From: Clive Fussell
Sent: 11 October 2012 11:21
To: 'Kyte KatieJane'
Cc: Lau William; Lousley Steve
Subject: RE: Consolidated Developments - queries
Attachments: PT-12062-DBF-BP-01pdf.pdf; Halcrow drawings.pdf; S062-002P2.pdf; S062-008P4.pdf

1. In the Agreement the proposed construction sequence is shown in Buro Happold drawing S062-002/P2, which shows that the oversite development basement construction would follow directly on from the construction of the escalator box and without the need for any temporary backfill. A compressible void former is provided between the oversite development basement and the permanent fill to the escalator box to prevent load transfer. This construction sequence would not change the loading on the escalator box, however during the development of the design for the Consolidated Piles it became clear that it was unlikely that the basement construction would follow directly after the escalator box construction due to programme issues relating to planning, occupation of the works site by LUL and the construction of the Crossrail tunnels. As a result it was decided (in a meeting with London Underground - Ralph Freeston) to temporarily backfill the excavat

Drawing No: HAG-N105-8742-STR-D-SEC-X-02510

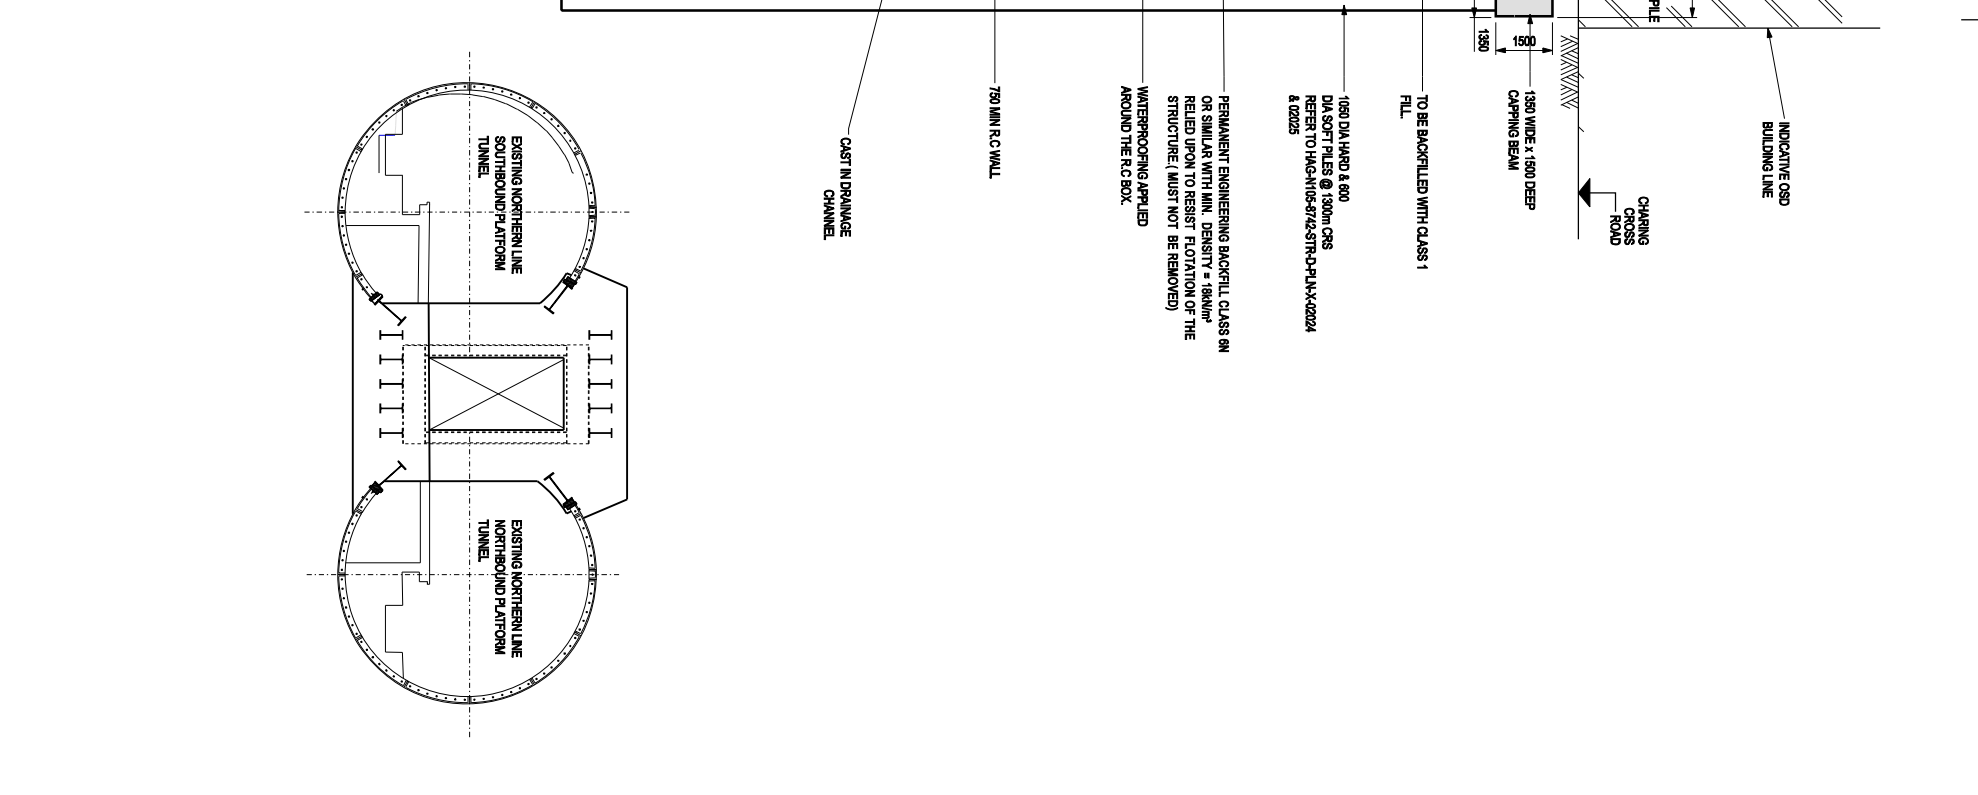
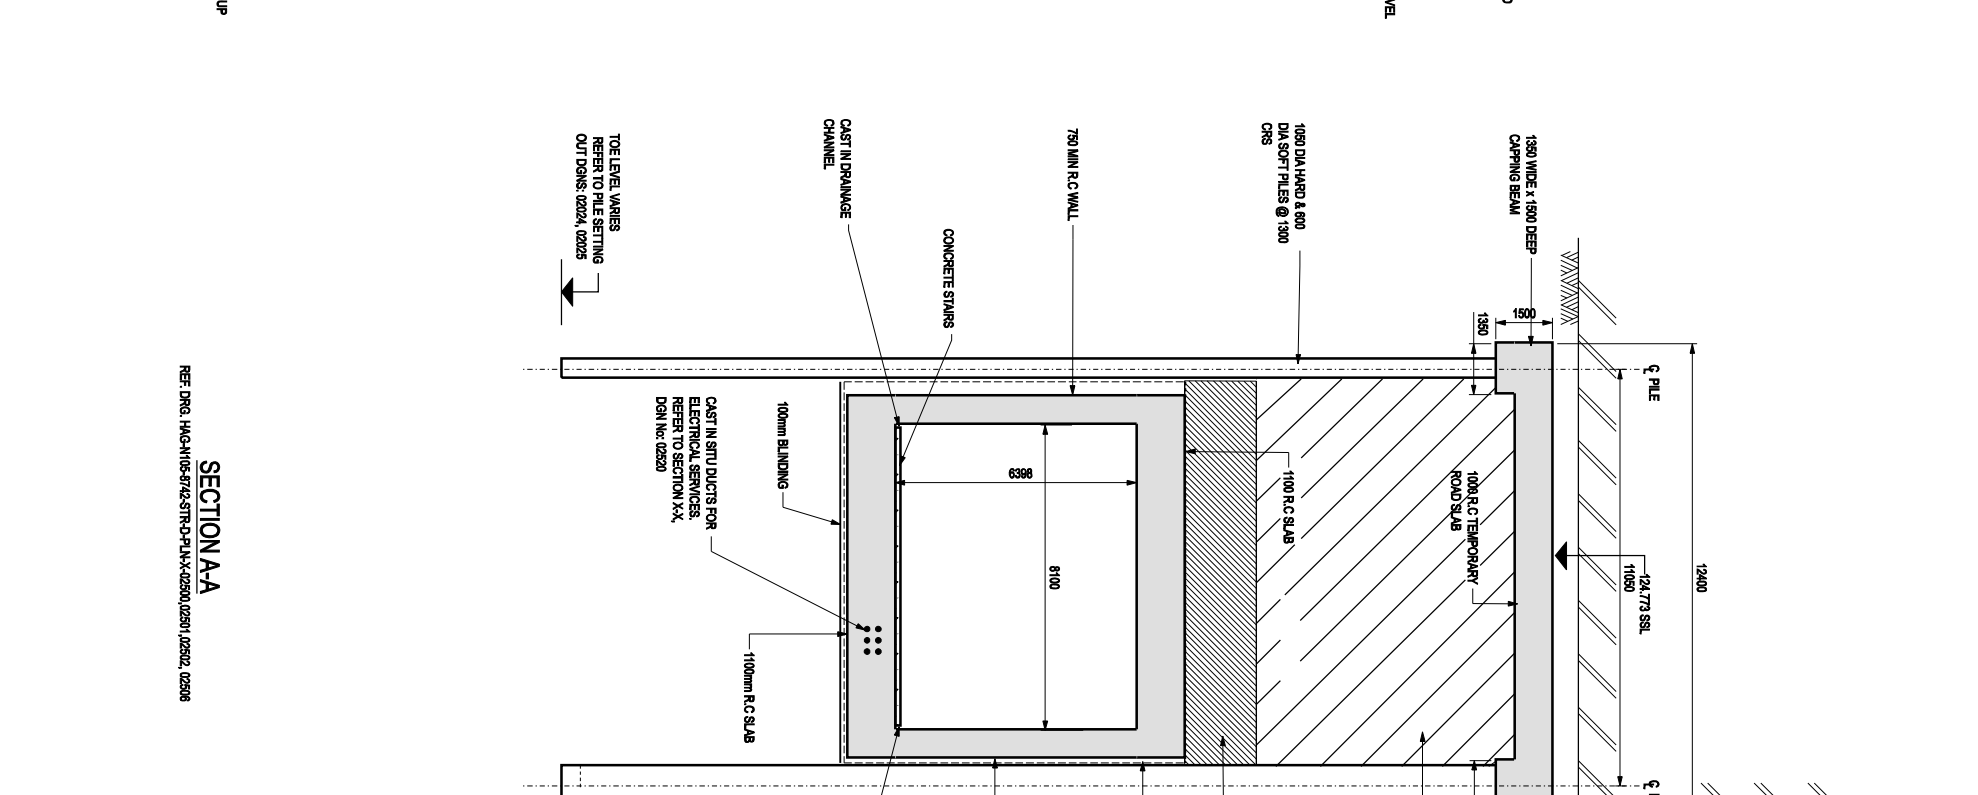
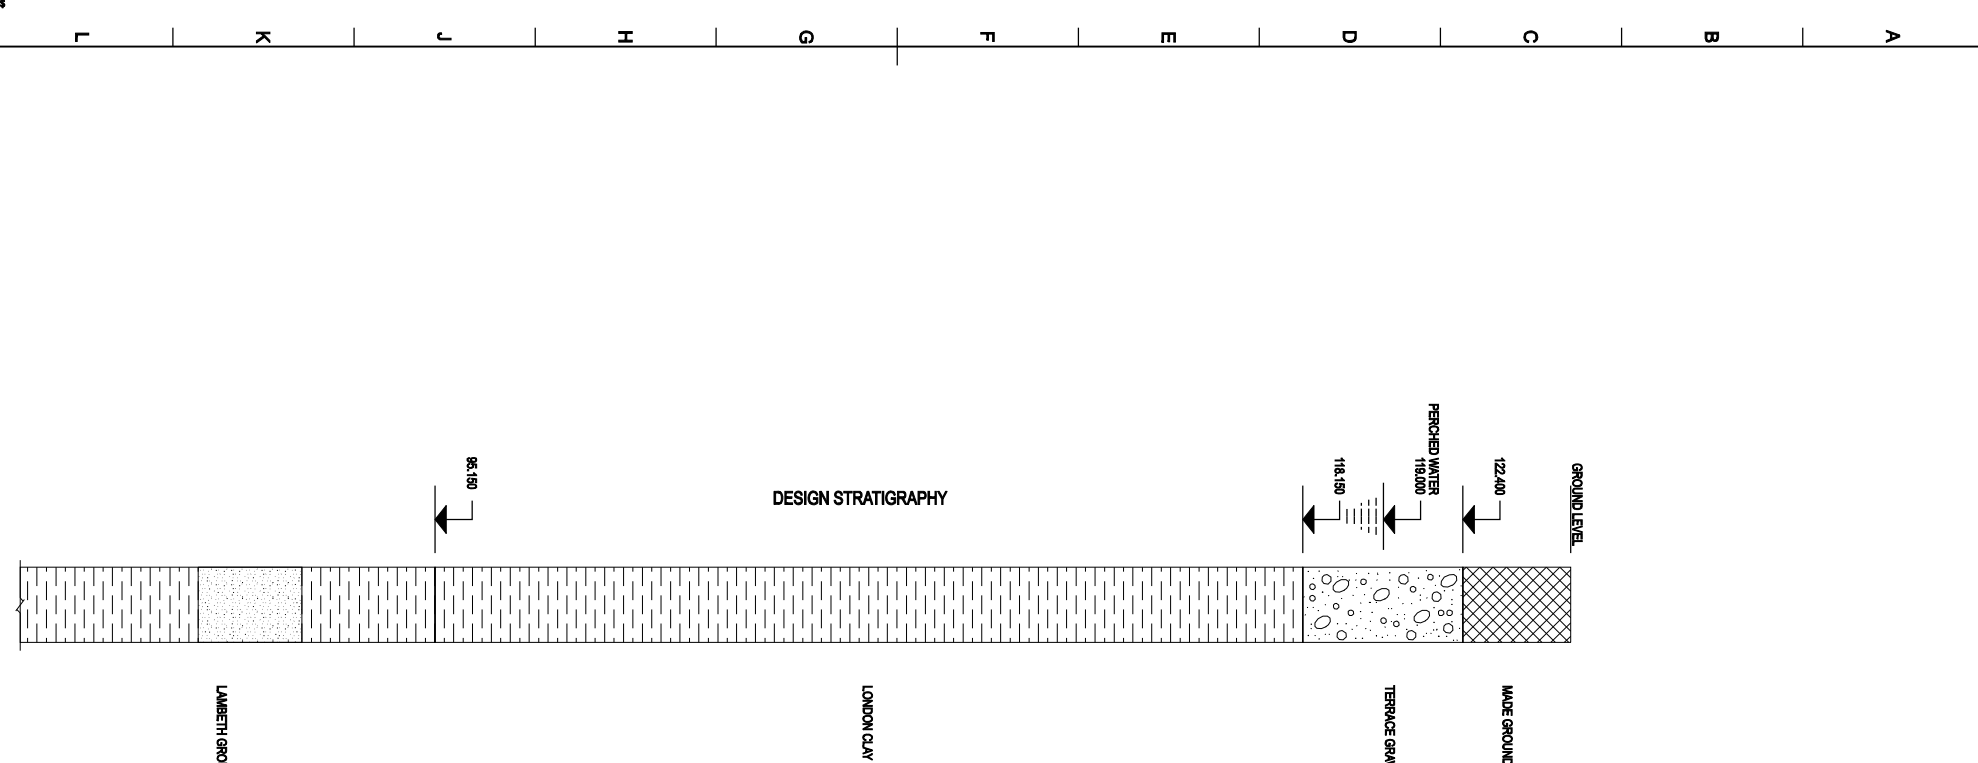
that the basement construction would not go below +114m. This is why the tunnel sleeve transfer drawing shows the ownership transferring at +114m and the Halcrow RIBA Stage E drawings (HAG-N105-8742-STR-D-SEC-X-02512/01) that were appended to final version of the Conceptual Design Statement shows the top of the permanent fill (and the demarcation layer) at the lesser of +114m or 2.0m above the top of the escalator slab.

- 1) As has been raised before, in your design drawings you will be excavating for your basement 2m above our escalator decline. Can you advise what the predicted movements are due to your works and demonstrate how you intend to ensure that the escalators are not adversely affected based on the programme of escalator installation.
- 2) On the Development Agreement the "Tunnel Sleeve transfer" drawing which appears on pages 93 & 210, the "available space for OSD basement construction" is defined as extending to 116.0m AOD. The engenuiti drawing 029_SK046 Section A shows the proposed basement extending to 114m. Please can you clarify.

During the development of the oversite design the structural zone required for the basement slab (including drainage) has been reduced to 1200mm with a 100mm allowance for site preparation. In order to maximise the usable space the basement slab level has been reduced to +115.3m without affecting the ownership or interface with the permanent fill below.

Notwithstanding the ambiguity noted above, we understand that there are technical issues with constructing the basement structure above the lesser of +114m or 2.0m above the top of the escalator slab.

Rev No: 009942
Drawing No: S062-008
Rev: P4

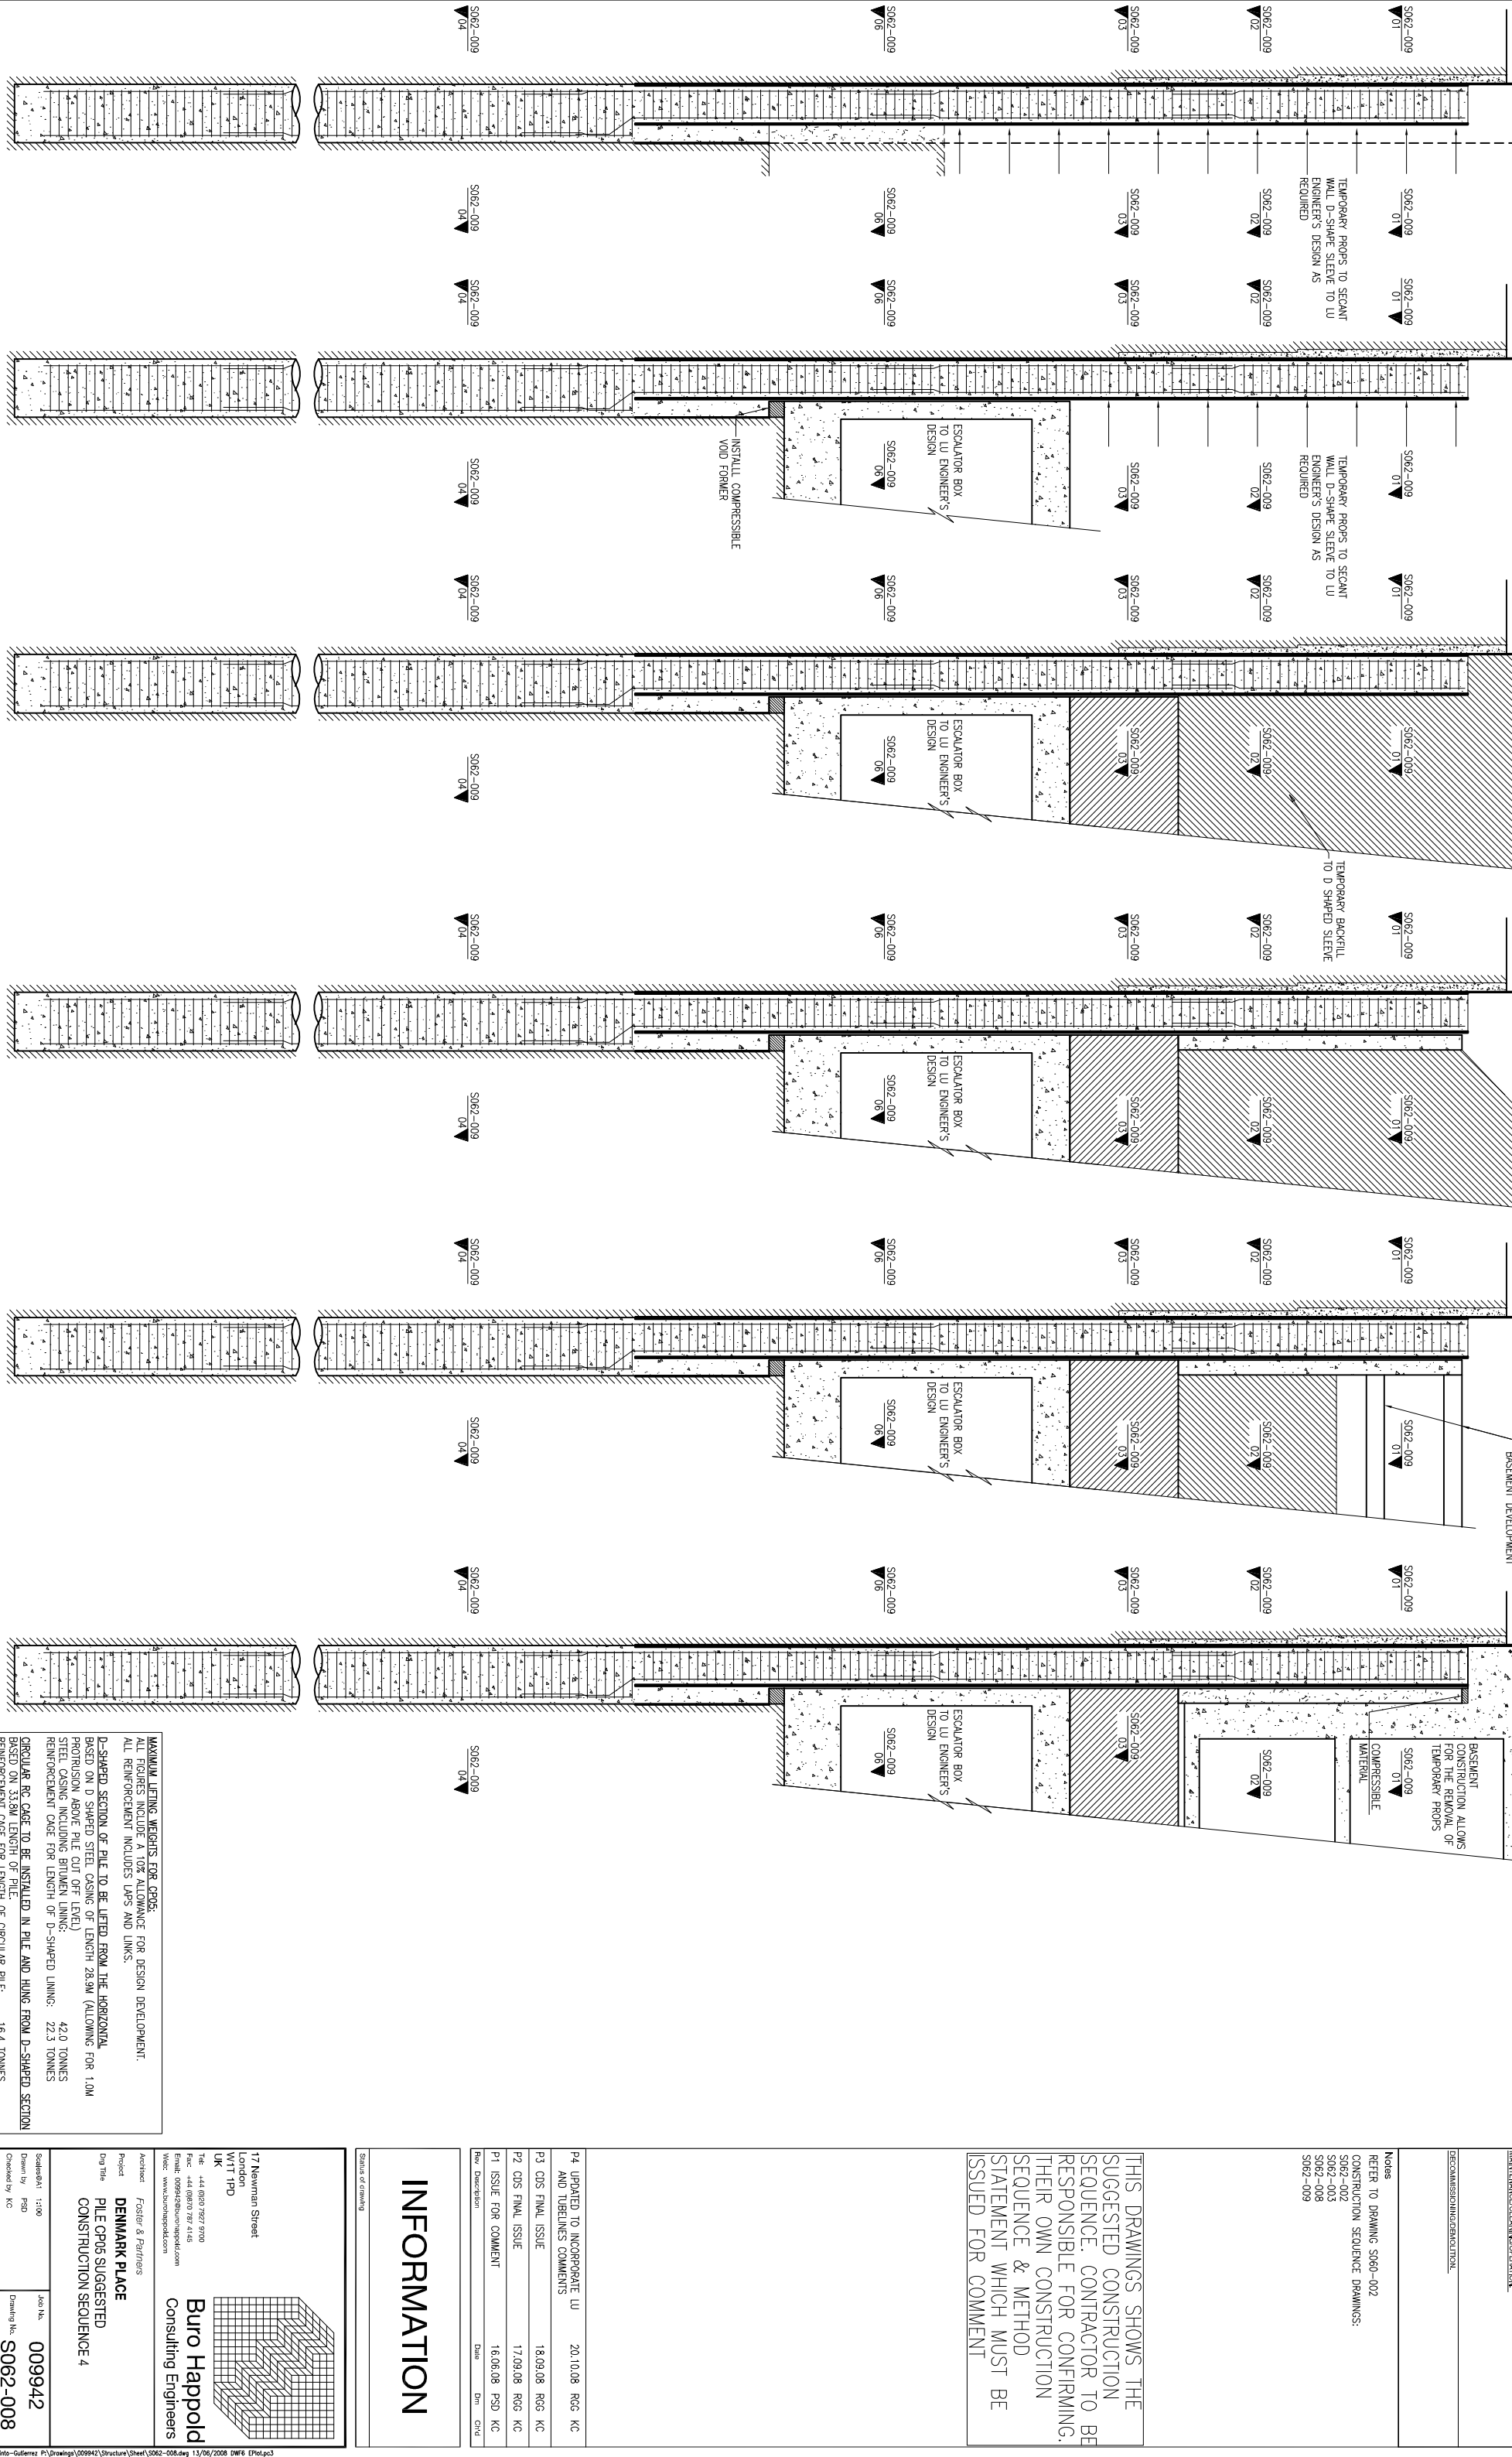
At our meeting on 1st June 2012 the option of not temporary backfilling the excavation above the permanent backfill was discussed with LUL, who confirmed (email 2nd August 2012) that they would proceed with the temporary backfill. The excavation above the escalator box will therefore remove the some of the temporary backfill that was placed in the summer of 2012, and is in line with the backfilling and excavation sequence shown on Buro Happold drawing S062-008/P4 (issued 20/10/2008). During the detailed design stage we will make a full 3d assessment of predicted movements during construction.

Assuming a worst case scenario of a 'green field' site with no interaction with adjacent structures, preliminary calculations would give an immediate and short term heave movement of 20mm associated with removing the temporary backfill at the maximum depth of excavation. The adjacent structures including the escalator box, secant piled wall and Consolidated Piles will reduce the movement that the escalator box experiences and we would anticipate a vertical movement in the order of 5-10mm (perhaps ever so slightly less). This would be a best estimate prediction without any significant degree of conservatism.
